**CITY OF TEMPE
DEVELOPMENT REVIEW COMMISSION**

**Meeting Date: 2/25/2014
Agenda Item: 2**

ACTION: Request for a Development Plan Review for eight new attached single-family townhomes for KENNETH PLACE TOWNHOMES, located at 1419 South Kenneth Place. The applicant is Neil Tang.

DPR13316 Development Plan Review including site plan, building elevations, and landscape plan

Site plan
 Scale: 1/8" = 1'-0"
A1.0
 Preliminary site plan
 10 January 2014

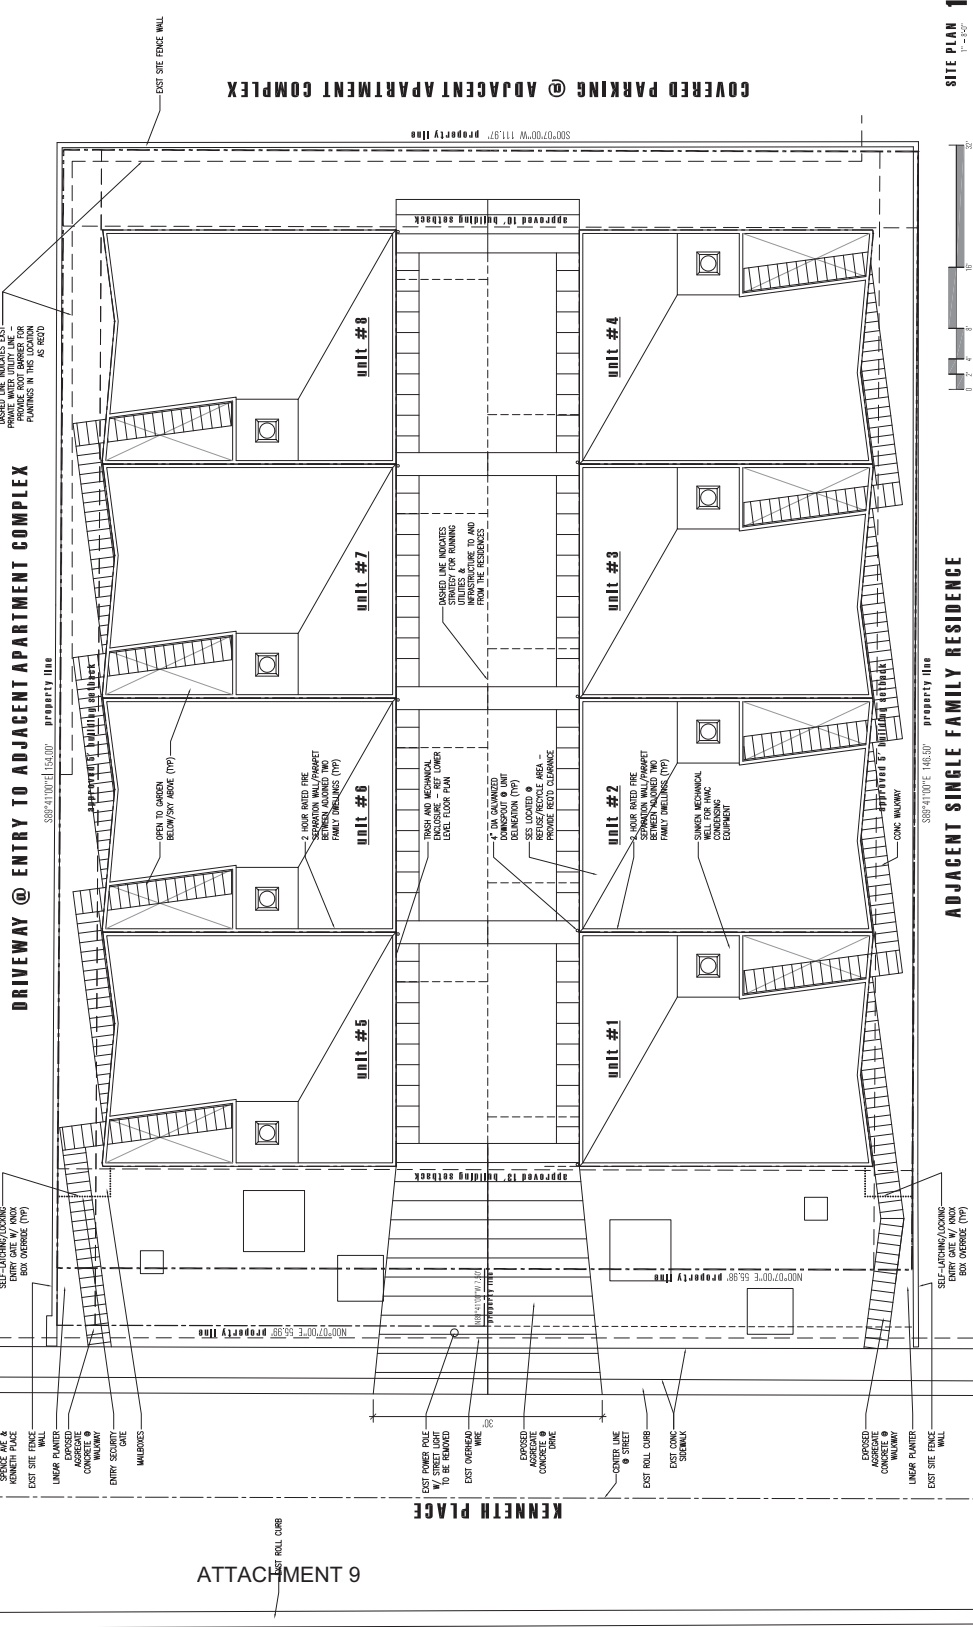
The plan has two rectangular buildings oriented with the short elevation facing the street. The existing surrounding developments have buildings that appear to be set back approximately 20 feet from the drip line to the back of sidewalk, as measured by aerial. There is a relatively large street right of way on the east side of Kenneth Place, and the proposed PAD would allow a 13 foot street side setback, with the additional right of way bringing the units to 20 feet back of sidewalk, similar in proximity to the existing developments on the street. The eight-unit community has a shared common drive. Circulation is entirely on-site, and provides room for exiting and entering from Kenneth Place without a significant traffic increase. The street front is landscaped in a contemporary low-water use concept to provide shade and visual interest to the project. The differences from the original plan to the current plan (both provided in attachments for reference) are:

- each unit has a two car garage, rather than a single car garage and an adjacent outdoor space between units.
- front doors are located on the north and south side of the site, rather than adjacent to the garages on the interior
- access to the units is via gates at the street front for security; guests are allowed in by the residents; gates have been added to the proposed plan at the entry courtyard to each unit, providing a secure courtyard to address Commission concerns and add an area for pets.

2. Provide 5'6" wide public sidewalk along Kenneth Place as required by Traffic Engineering Design Criteria and Standard Details.
3. Provide gates of steel vertical picket, steel mesh, steel panel or similar construction. Provide gates of height that match that of the adjacent enclosure walls. Review gate hardware with Building Safety and Fire staff and design gate to resolve lock and emergency ingress/egress features that may be required.

4. Provide upgraded paving at driveway consisting of unit paving. Extend this paving in the driveway from the right-of-way line to 20'-0" on site and from curb to curb at the drive edges. From sidewalk to right-of-way line, extend concrete paving to match sidewalk.

colored
building elevations
scale : 1/8" = 1'-0"

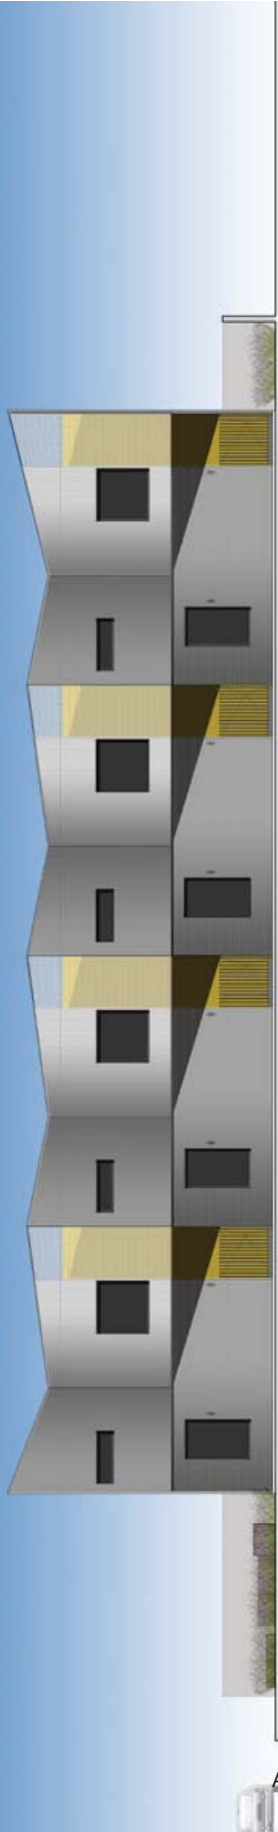
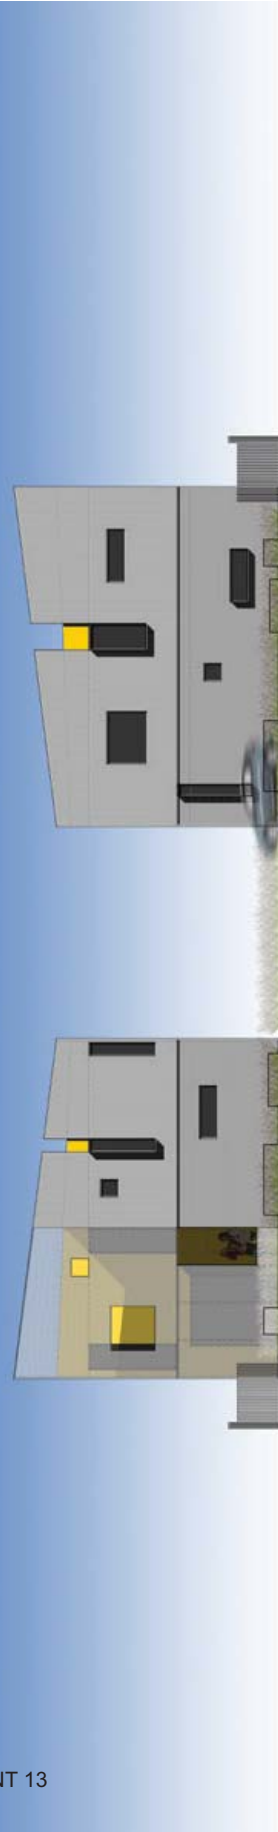
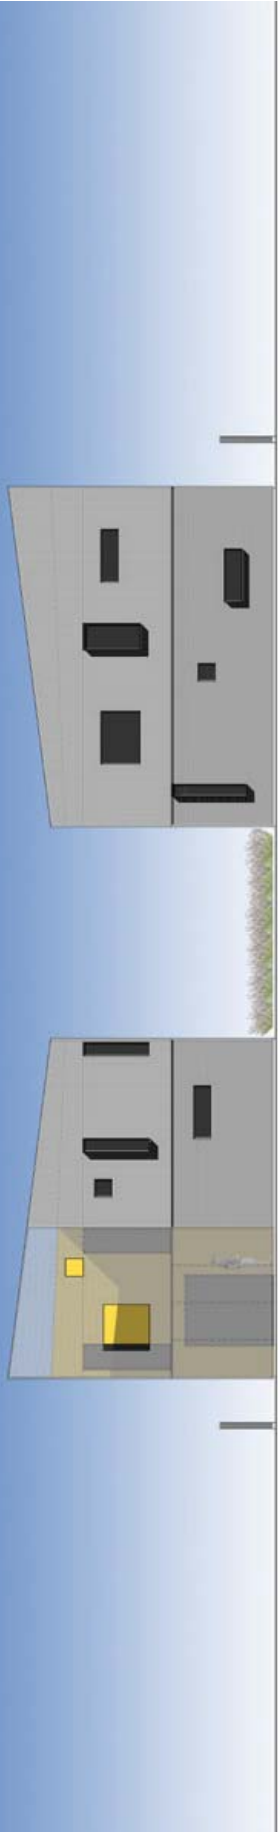
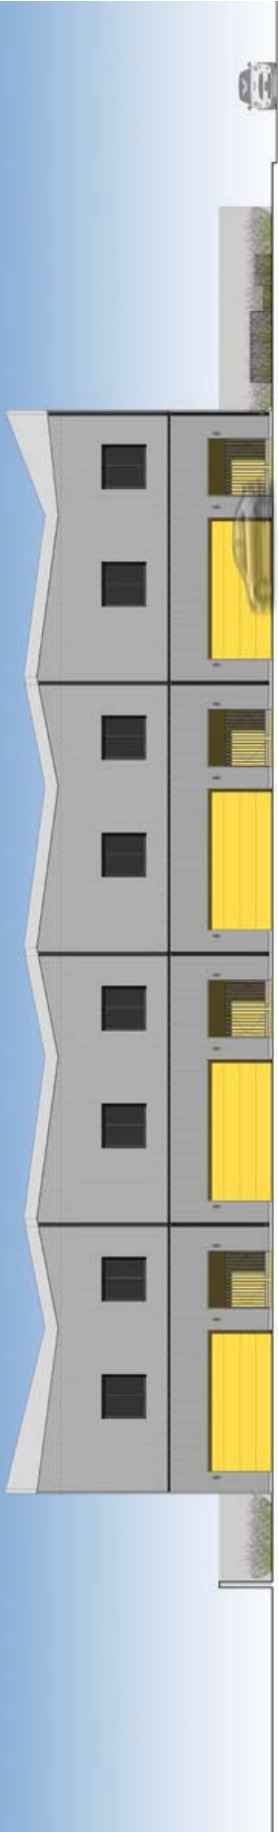
- The north elevation of building 'a' and south elevation of building 'b' which are the elevations of the drive entry have been altered to configure the windows such that they align. Wall sconces have also been added for additional security;
- Additional perspective renderings and detailing images were provided;
- A sample of the perforated corrugated metal was provided.

Based on input from the Commission at the first hearing, the designer has added more windows and openings on the street front, with a perforated material on the street front building elevation of the north building. The units have a more residential

appearance and provide more interaction with the street from the courtyard and the unit. The south building has windows from the rooms on both the first and second floor to provide surveillance of the street front.
